Subj: RESPONSES TO COMMENTS ON DRAFT FIELD SAMPLING PLANS FOR
THE FOLLOW-ON FIELD WORK FOR PHASES 2B/3 AND 5/6 SITES AT NAS
ALAMEDA

RESPONSE TO DTSC COMMENTS
Phases 2B and 3 Draft Follow-On Field Sampling Plan

**RESPONSE TO DTSC COMMENTS
Phases 5 and 6 Draft Follow-On Field Sampling Plan**

RESPONSE TO RWQCB COMMENTS
Phases 5 and 6 Draft Follow-On Field Sampling Plan

FIGURE 13-3

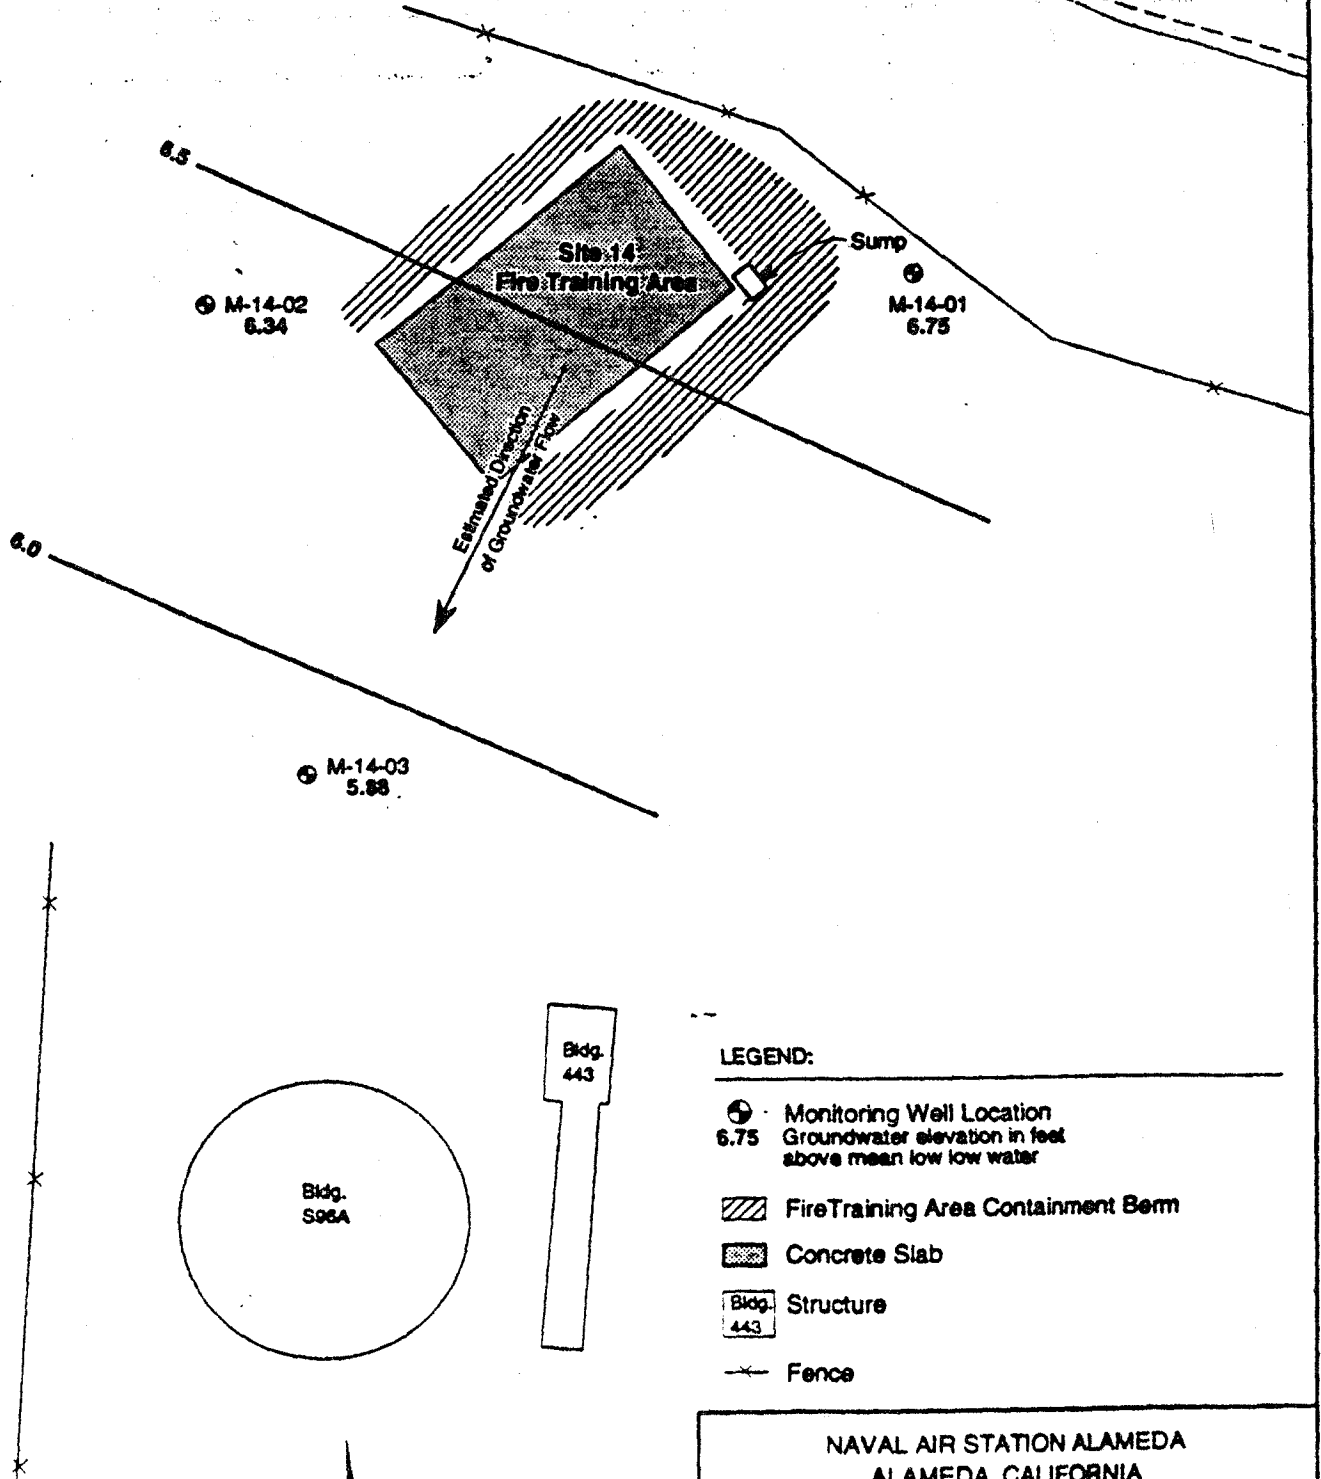
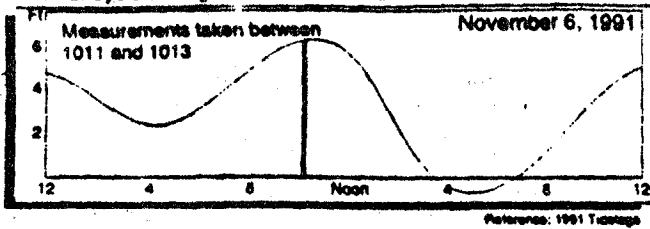
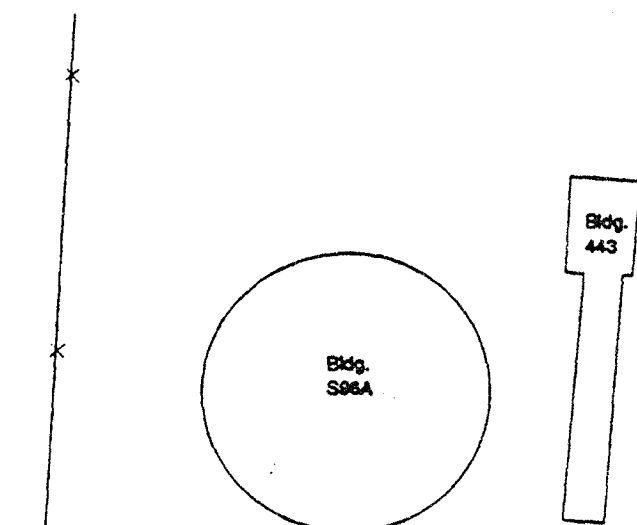
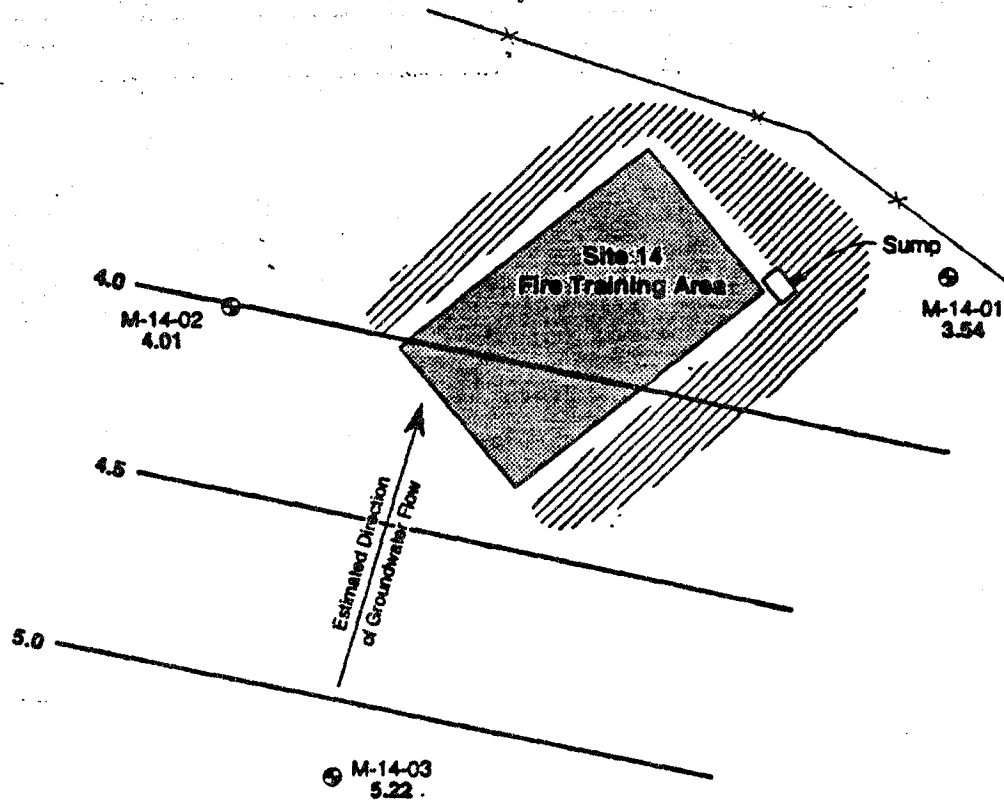
The configuration of the groundwater table during low and high tide as shown in Figure 11-4 and 11-5 are different than the configurations shown in Figure 13-3 and 13-4 of the Final Data Summary Report for Phases 2B and 3. What conclusions can be made about the direction of groundwater flow at Site 14?

While responding to this comment, errors were discovered in both the tidal influence study analysis and original DSR water level contour maps for Site 14. The tidal study errors involved the surveyed top of casing data for wells M14-02 and M14-03 and the initial depth to water data for both wells. Well M14-01 remained unchanged. The data have been corrected, and new maps and calculations are included with these responses. The data for the other tidal influence study sites are currently being checked. Any changes in the data will be made in the CTO 0121 final DSR Background and Tidal Influence Studies/Additional Work at Sites 4 and 5 document and the results will be changed accordingly.

The surveyed top of casing information for wells M14-02 and M14-03 were transposed in the original DSR water level contour maps for Site 14. These maps have also been corrected and are resubmitted with these responses.

The corrected tidal influence data indicate that all three wells exhibit tidal influence. During low tide, flow at Site 14 is towards the Inner Harbor, with a hydraulic gradient of approximately 0.012 foot per foot (fpf). At high tide, the groundwater flow direction is away from the Inner Harbor, with a hydraulic gradient of approximately 0.013 fpf. The high and low tide maps are now consistent between the DSR and the tidal influence study. The average groundwater flow direction for the site is southwest (away from the Inner Harbor), under an extremely low hydraulic gradient of approximately 0.00068 fpf (nearly flat).
